Access Compliance Report Public Rights-of-Way (Curb Ramps)

Main Street: TIGERTAIL_DR		Cross Street: OAK_WAY_DR		Location:	SE
ADA ID: RPRK211208112017	Ramp Type:Type 1 - Perpendicular Diagonal Initial Pass/Fail: Fail		Overall Compliance: No	Severity Score:	2
Codes/Mitigation Info/Possible Solution			Field Measurements/Component Compliance

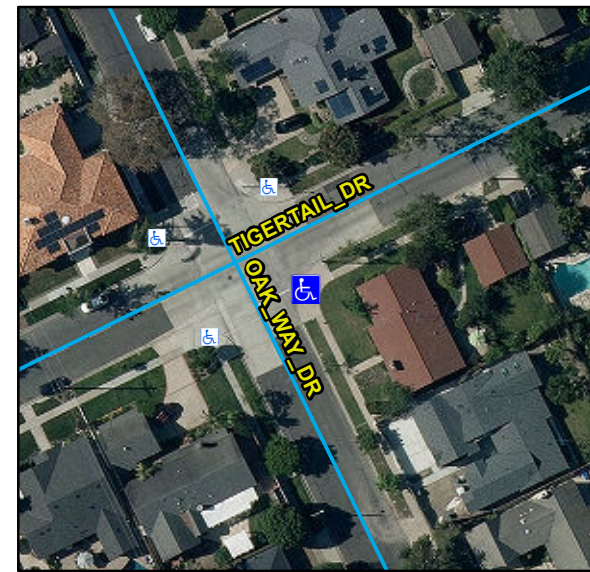
Compliance	Description	Data	Compliance	Description	Data
N/A	Ramp Length (in)	125	N/A	Flare Type LT	
Yes	Ramp Width (in)	48			N/A
Yes	Ramp Run Slope (%)	4.4	N/A	Flare Slope LT (%)	N/A
No	Ramp Cross Slope (%)	2.4	N/A	Flare Traversable LT	N/A
N/A	Landing Present	N/A	N/A	Flare Type RT	
N/A	Landing Length (in)	N/A			N/A
N/A	Landing Width (in)	N/A	N/A	Flare Slope RT (%)	N/A
N/A	Landing Run Slope (%)	N/A	N/A	Flare Traversable RT	N/A
N/A	Landing Cross Slope (%)	N/A	N/A	DWS Provided	N/A
N/A	Landing Movement Obstructed?	N/A	N/A	DWS Contrast	N/A
	Landing Movement Type	N/A	N/A	DWS Length (in)	N/A
N/A	Landing Shared	N/A	N/A	DWS Full Width	N/A
N/A	Clear Space	Yes	N/A	DWS Offset Left (in)	N/A
N/A	Clear Space To Crosswalk (in)	N/A	N/A	DWS Offset Right (in)	N/A
N/A	Marked Crosswalk 1	No	N/A	Marked Crosswalk 2	No
	Crossing 1 Direction	N		Crossing 2 Direction	W
	Marked Crosswalk 1 Width (in)	N/A		Marked Crosswalk 2 Width (in)	N/A

N/A	Ramp Inside Crosswalk 1	N/A	Yes	Ramp Inside Crosswalk 2	N/A
	Crossing 1 Slope (%)	3.2		Crossing 2 Slope (%)	0.1
	Crossing 1 Cross Slope (%)	0.7		Crossing 2 Cross Slope (%)	3.7
N/A	Gutter Ponding	N/A	N/A	Curb Slope	3.9
No	Gutter Lip Height (in)	1		Road Run Slope (%)	2.8
N/A	Gutter Run Slope (%)	N/A		Road Cross Slope (%)	2.5
N/A	Gutter Cross Slope (%)	N/A			
Yes	Overall Surface Condition: Acceptable		No	Perp Joint Present	No
	Cross Gutter Present?	Yes		Spandrel Present?	Yes
	Replace Cross Gutter?	No		Replace Spandrel?	No

Remove & Replace Curb Ramp With Two New Directional Ramps or Equivalent. Grind Gutter Lip.
